PCN – Process Change Notification

Change:	FW.90.SMA.M
Date:	2017/08/04
Author	Haley Tsai

Model#	Part Number	Changes
FW.90 Penta-band Cellular Flexible Whip Antenna SMA(M) Straight	FW.90.SMA.M	<ol style="list-style-type: none"> 1. Amend $\varnothing 4 \pm 0.3\text{mm}$ to $3.7 \pm 0.2\text{mm}$. 2. Amend $\varnothing 61 \pm 0.3\text{mm}$ to $\varnothing 61 \pm 0.5\text{mm}$. 3. Amend $\varnothing 16.05 \pm 0.2\text{mm}$ to $\varnothing 16 \pm 0.5\text{mm}$. 4. Amend cap material from ABS to POM.

Illustration of Change

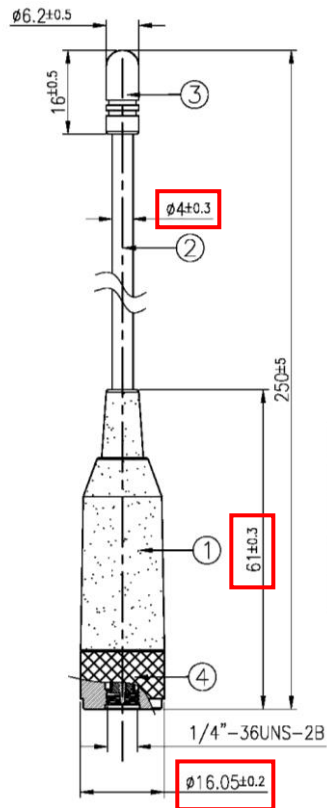
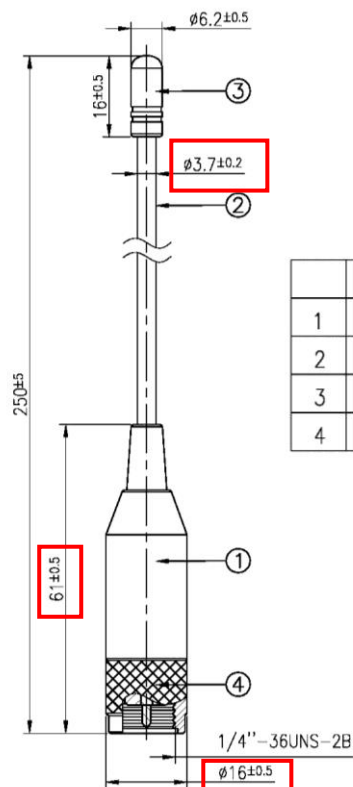
1. Amend $\varnothing 4 \pm 0.3\text{mm}$ to $3.7 \pm 0.2\text{mm}$.
2. Amend $\varnothing 61 \pm 0.3\text{mm}$ to $\varnothing 61 \pm 0.5\text{mm}$.
3. Amend $\varnothing 16.05 \pm 0.2\text{mm}$ to $\varnothing 16 \pm 0.5\text{mm}$.
4. Amend cap material from ABS to POM.
